**CITY OF LA VISTA
MAYOR AND CITY COUNCIL REPORT
DECEMBER 18, 2018 AGENDA**

Subject:	Type:	Submitted By:
APPLICATION FOR PUD SITE PLAN – LOT 1, SOUTHPORT EAST REPLAT FIVE (NW OF WESTPORT PKWY)	◆ RESOLUTION ORDINANCE RECEIVE/FILE	CHRISTOPHER SOLBERG CITY PLANNER

CASE NUMBER: PPUD-18-0005

RE: Hooters Restaurant
Proposed Planned Unit Development (PUD) Site Plan Amendment - Initial
Review

SITE PLAN	REV DATE 10/19/18 REV-3	SHEET NO. 2 of 19
---------------------------------------	-------------------------------	----------------------

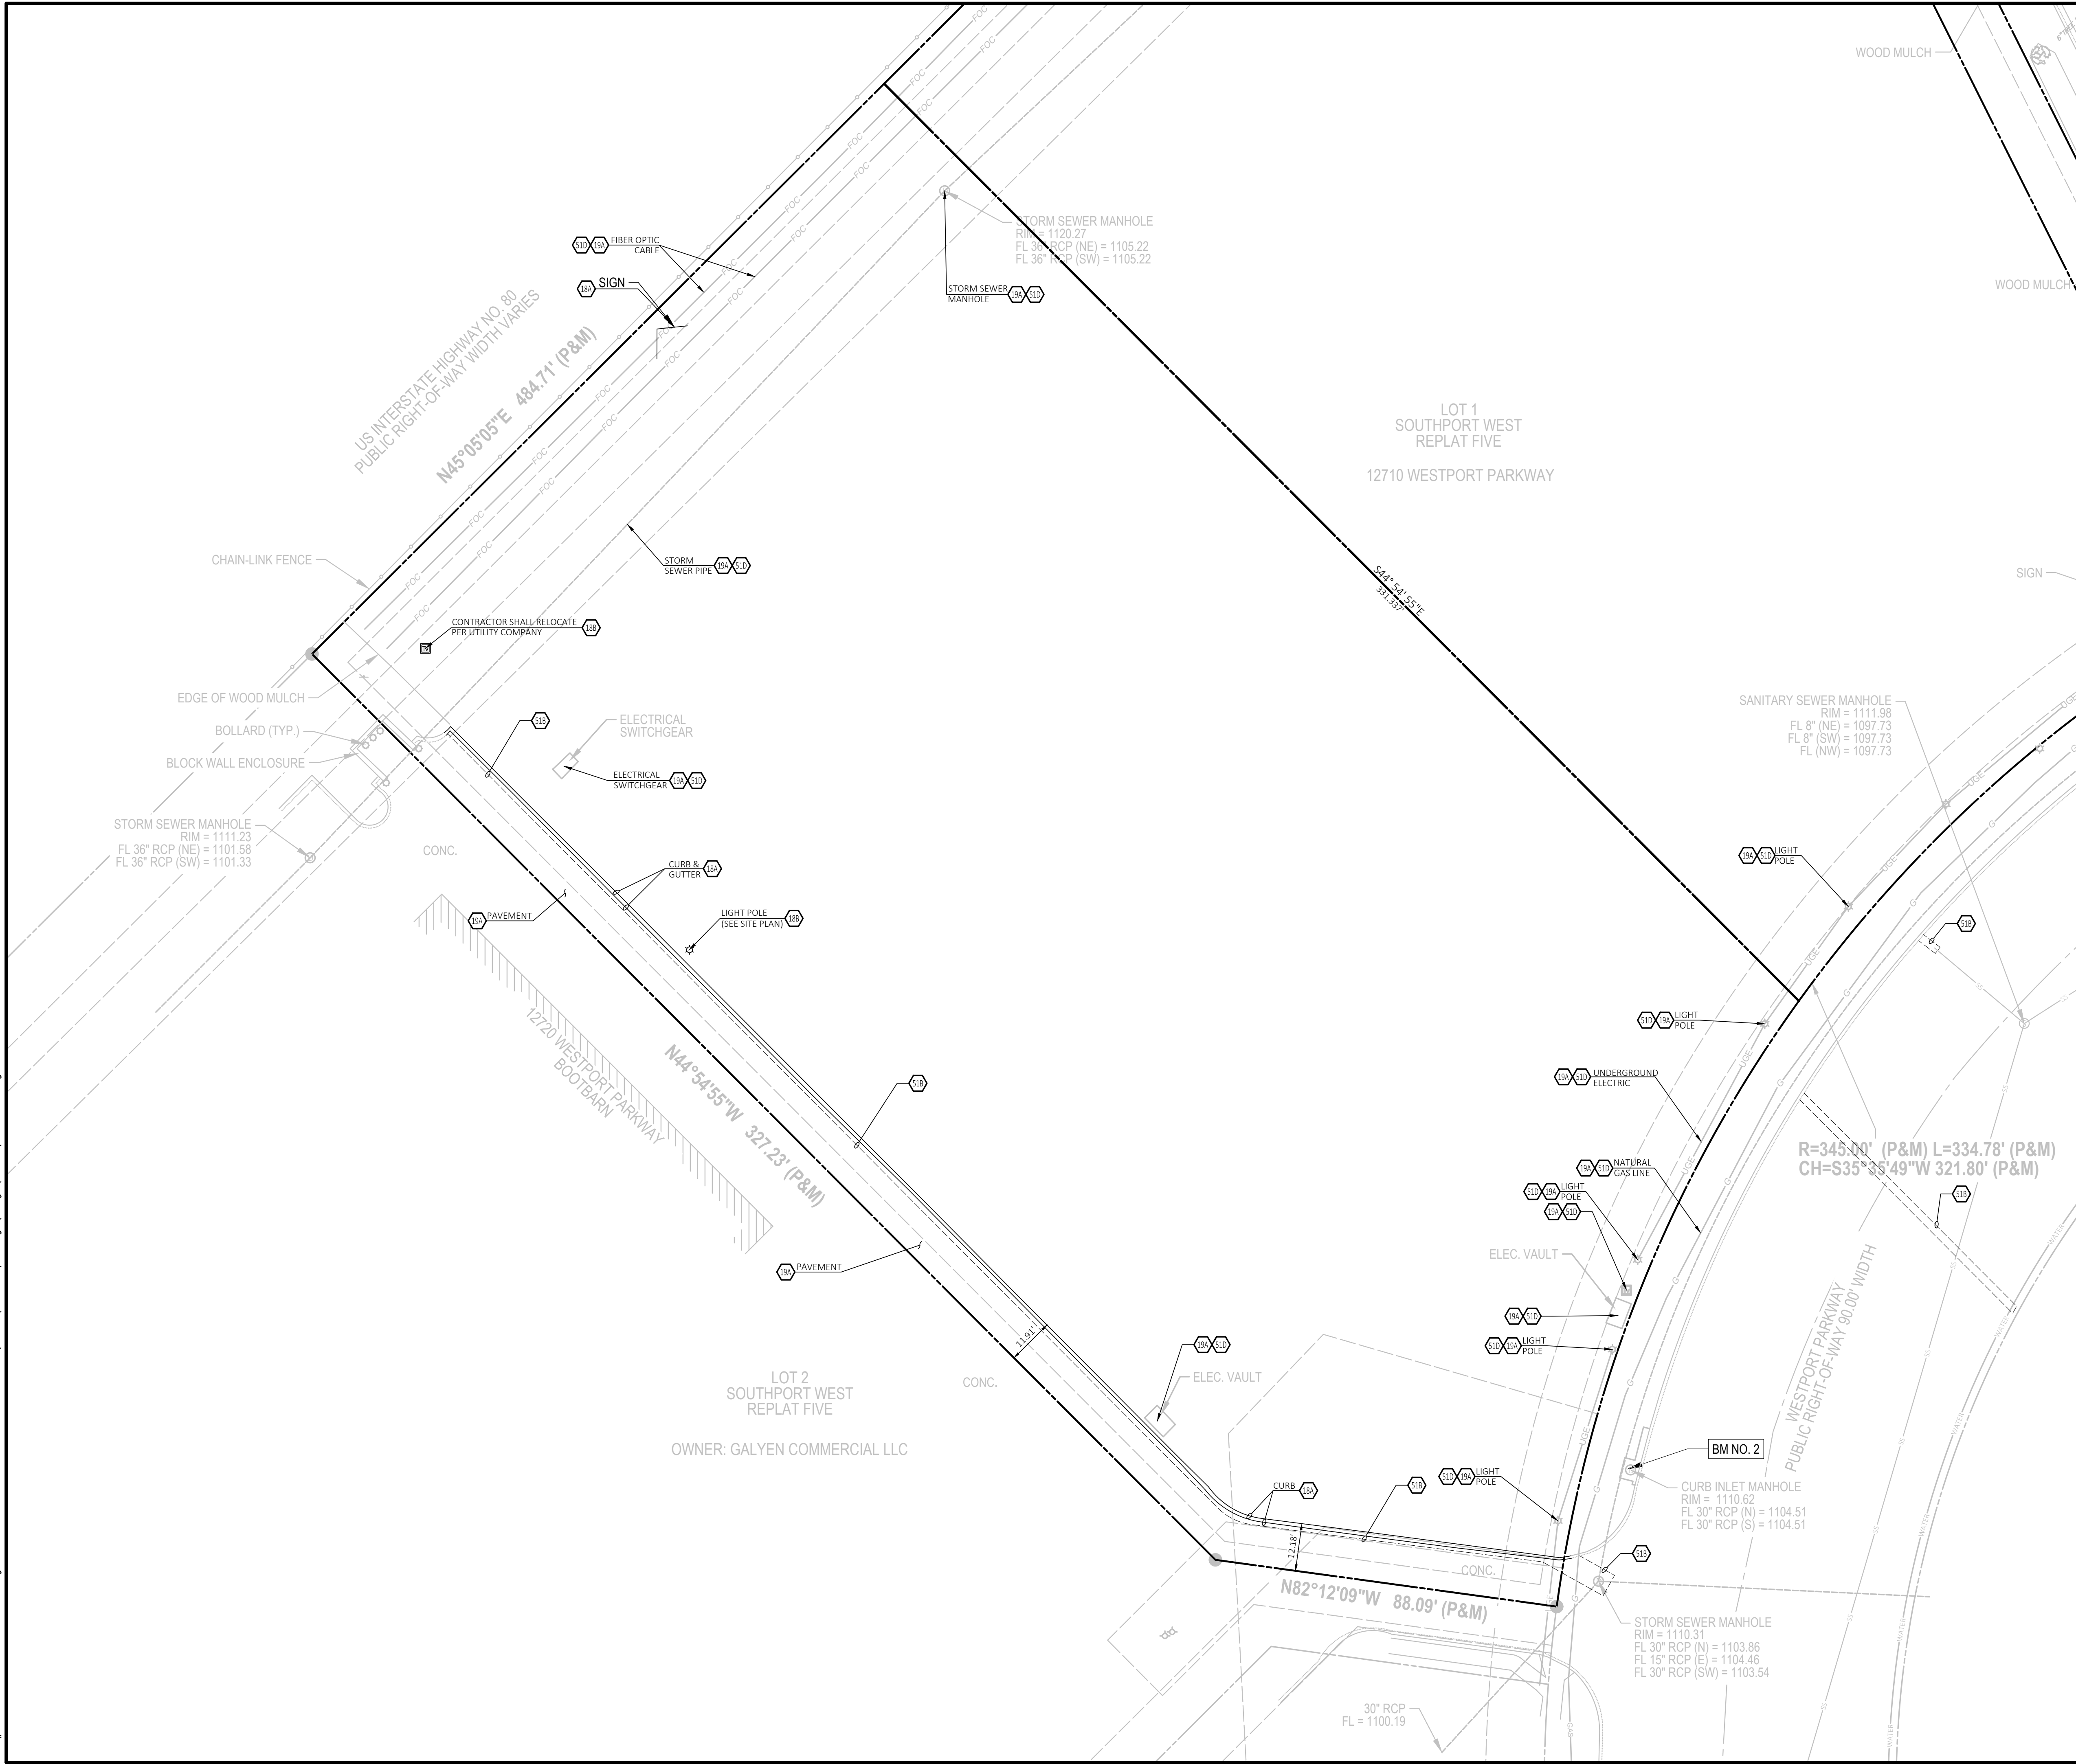
5. Article 5.15.04.06: The applicant needs to provide clarification on the data table that the parking info is NOT for all of Lot 1 and that the remaining undeveloped area will have to provide its own.

Please provide a note on Sheets 2 and 4 stating that there is to be a future extension of the driveway across the remainder of Lot 1 to reach the shared access point at the common line of Lot 1, Replat Five and Lot 16. The intention of this note is to try to avoid future conflicts if a connection is not illustrated as part of this plan set.

6. Article 5.15.04.07: The current PUD indicates that Lot 1 is not subject to sharing of parking with other lots. The plans indicate approximately 5,633 SF of gross floor area. The zoning regulations would require one stall per 100 square feet plus one space per employee on the peak shift. The gross floor area requires 57 stalls. The peak shift employment is not stated. The parking count is 114 stalls (110 without the "to-go" stalls) which most likely exceeds the requirement. The applicant needs to state the peak employment shift to complete the parking review. It should be noted that the data table on the Site Plan indicates required parking to be 112 spaces based on 1 per 100 sf, so some clarification is needed or correction to the data table. If there is excess parking, the applicant needs to indicate whether there will be shared parking with the remainder of Lot 1.

8. Article 5.15.04.09: The setbacks in the site information table and on the map of the site plan need to depict the setbacks set forth within Section 5.12.06.01 of the Zoning Ordinance. Specifically,

The Site Information table on the Site Plan (sheet 2 of 19) has been updated to state that the future development on the remainder of Lot 1 will need to provide its own parking.

Statement has been added to Sheets 2 and 4.

Hooters estimates to have (20) employees working during peak shift. The Site Information table on the Site Plan (sheet 2 of 19) has been updated to call out (20) employee parking spaces, and to state that the future development on the remainder of Lot 1 will need to provide its own parking.

The Site Information table on the Site Plan (sheet 2 of 19) has been updated to note the above minimum setback requirements.

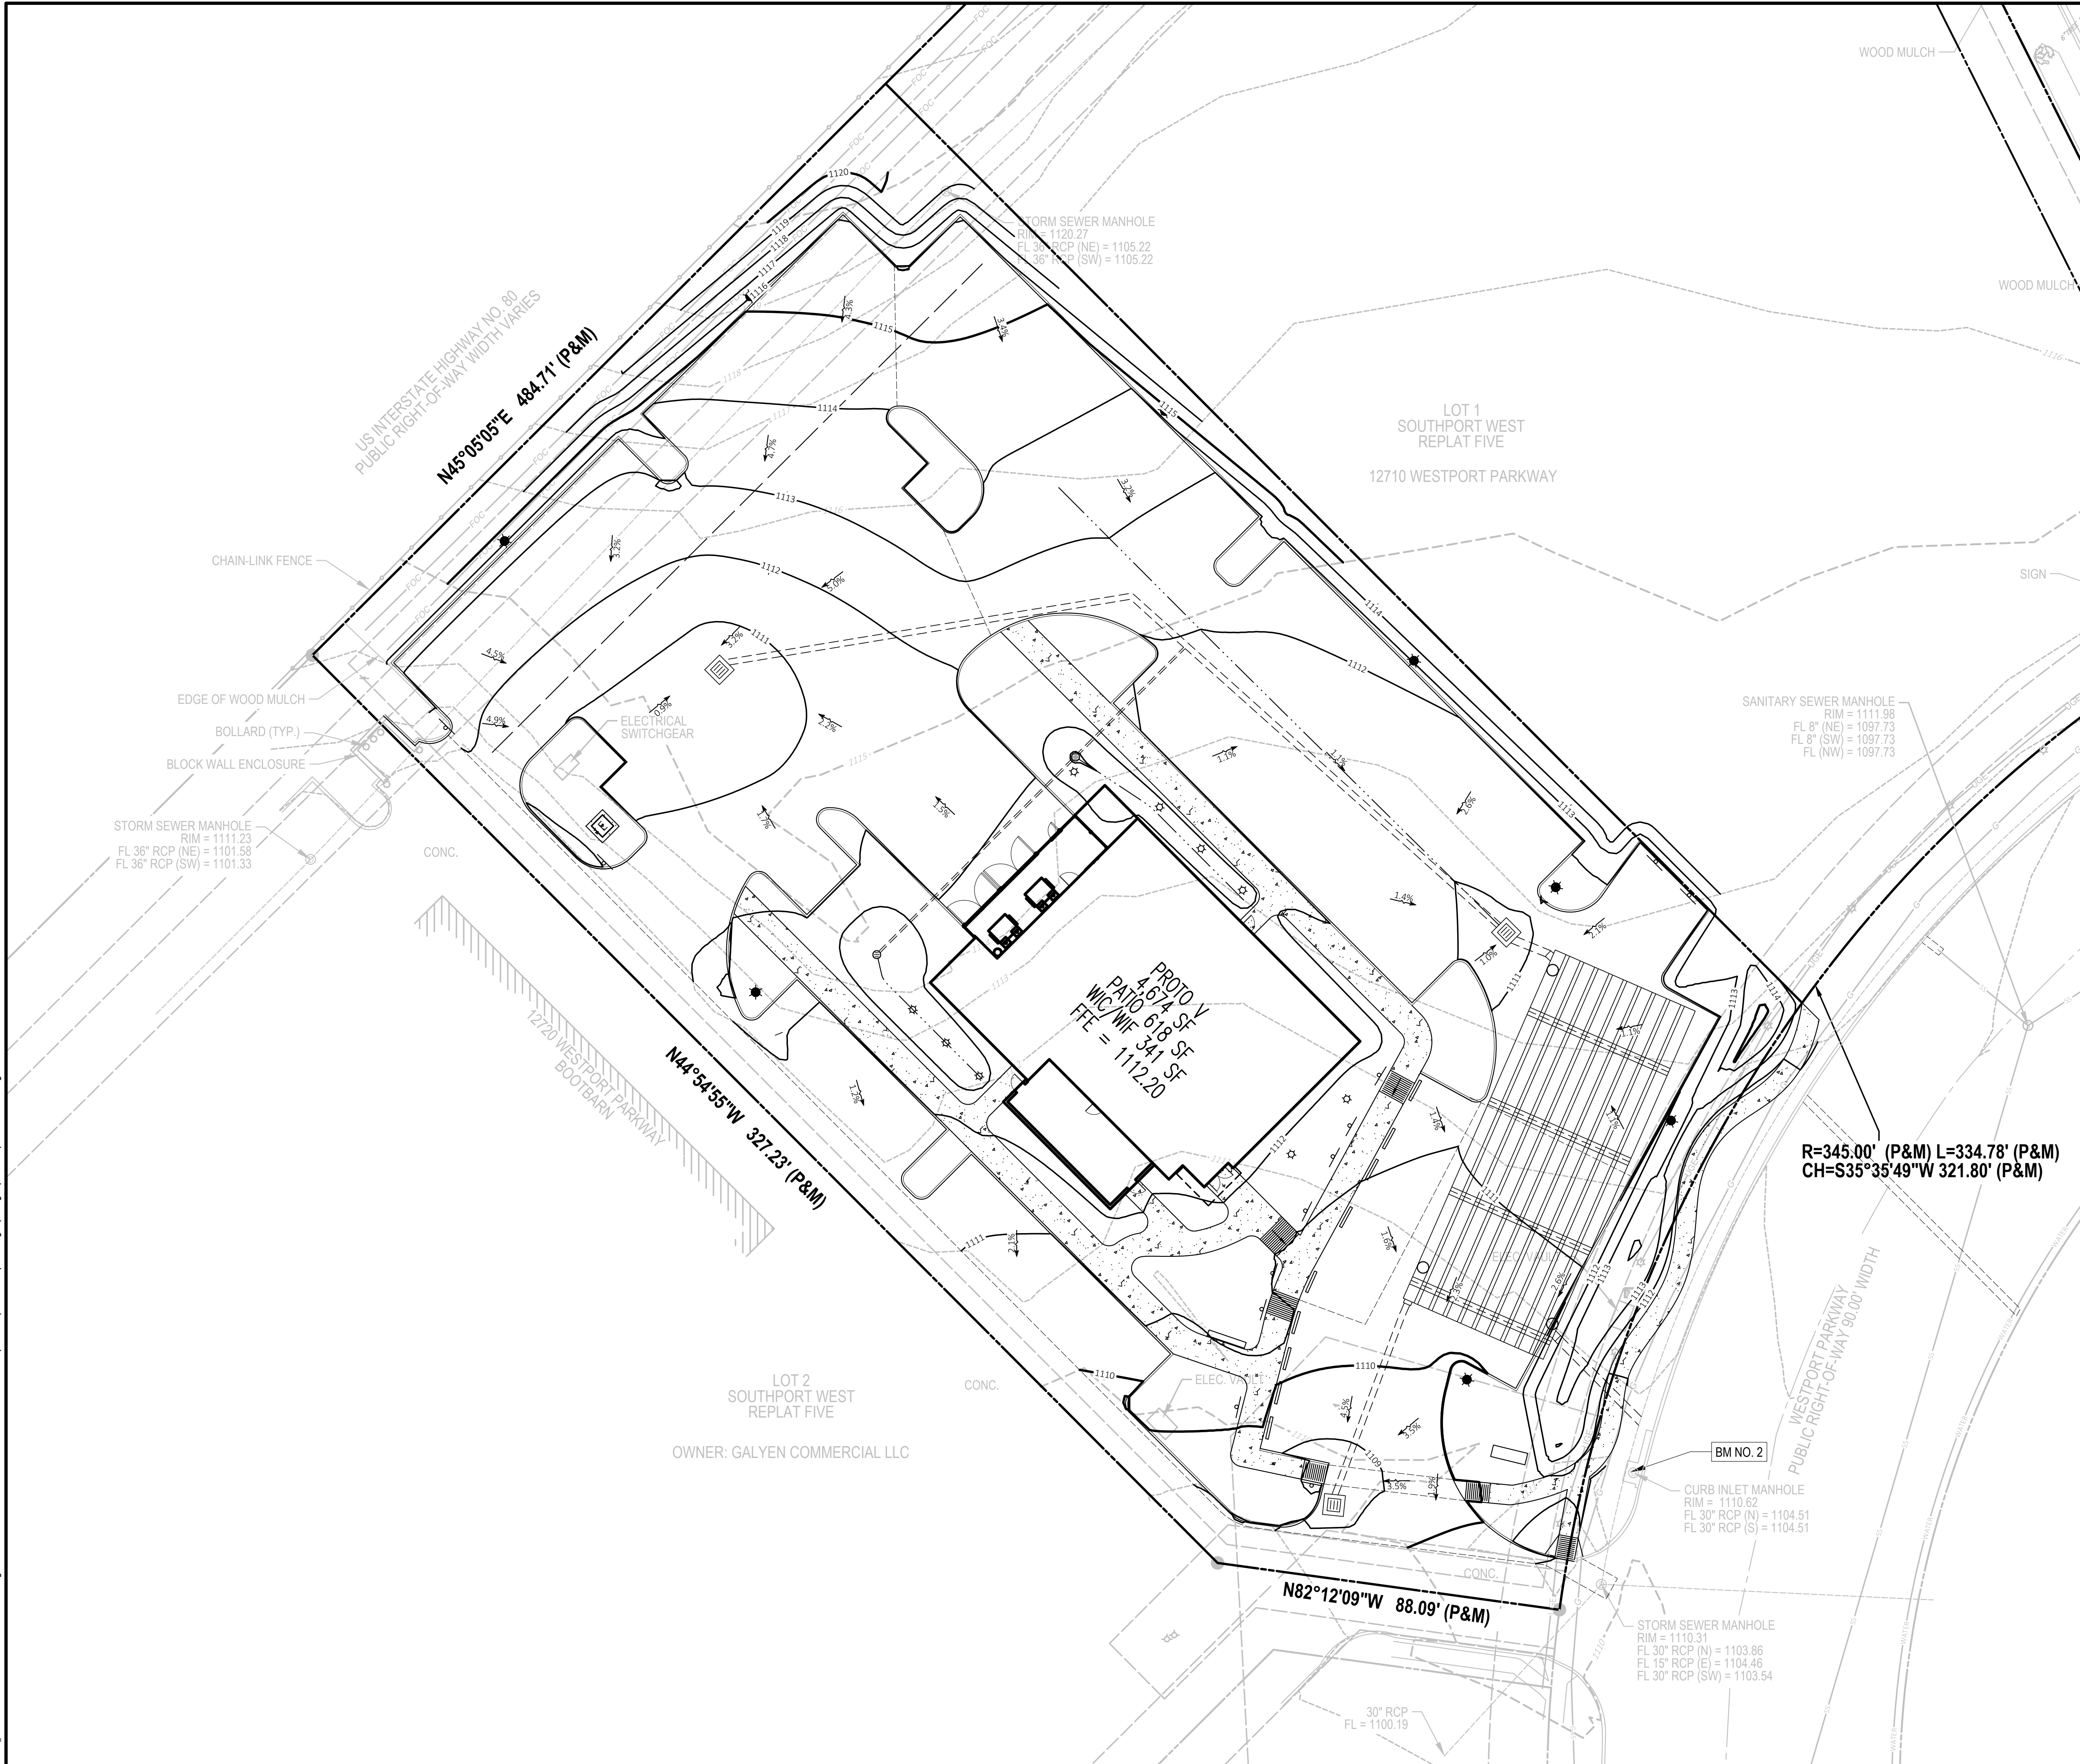
9. Article 5.15.04.14: Please provide a note on Sheets 2 and 4 stating that there is to be a future extension of the driveway across the remainder of Lot 1 to reach the shared access point at the common line of Lot 1, Replat Five and Lot 16. The intention of this note is to try to avoid future conflicts if a connection is not illustrated as part of this plan set.

The note has been added to Sheets 2 and 4.
